**Safety Recall 18S32 - *Supplement #1***

Certain 2012-2018 Model Year Focus Vehicles Equipped With 2.0L GDI and GTDI Engines

Fuel Tank Deformation

**FIGURE 1**

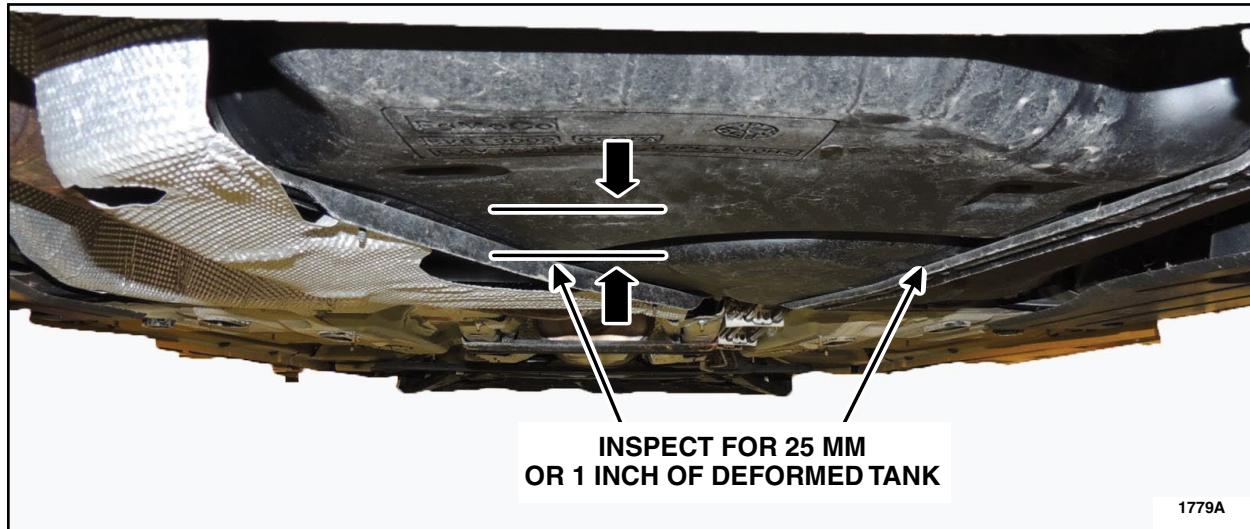
7. Inspect the fuel tank. Is the bottom of the fuel tank deformed more than 25 mm (1 in) upward?  
See Figure 1.

- a. No - Repair is complete.
- b. Yes - Replace the fuel tank and fuel delivery module. Please follow the WSM procedures in Section 310- 01.
